From: [Serge Bonte](#)
To: [Ramirez, Lucas](#); [Hicks, Alison](#); [Kamei, Ellen](#); [Matichak, Lisa](#); [Abe-Koga, Margaret](#); [Lieber, Sally](#); [Showalter, Pat](#)
Cc: [City Council FORWARD](#)
Subject: Re: 2/8/22 Meeting Agenda item 6,2 - Mixed-Use Development Project at 601-649 Escuela Avenue and 1873 Latham Street
Date: Tuesday, February 8, 2022 3:09:55 PM
Attachments: [image.png](#)

According to the El Camino Precise Plan adopted in 2019, the proposed project is designated as a primary pedestrian area (see map snippet from page 45 of the El Camino Precise Plan)

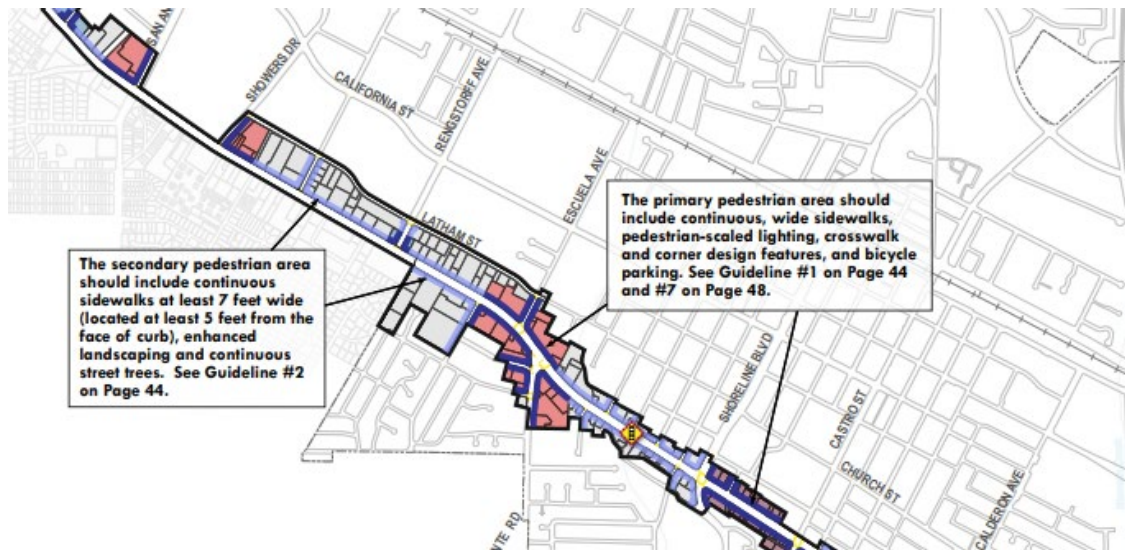
However, it's not clear that the proposed sidewalks -on a route to school- adhere to the El Camino Precise Plan streetscape guidelines.

Please ensure that the sidewalks have the required widths and buffer from the street as well as pedestrian-scaled lighting (a key feature for safety, especially that close to two elementary schools).
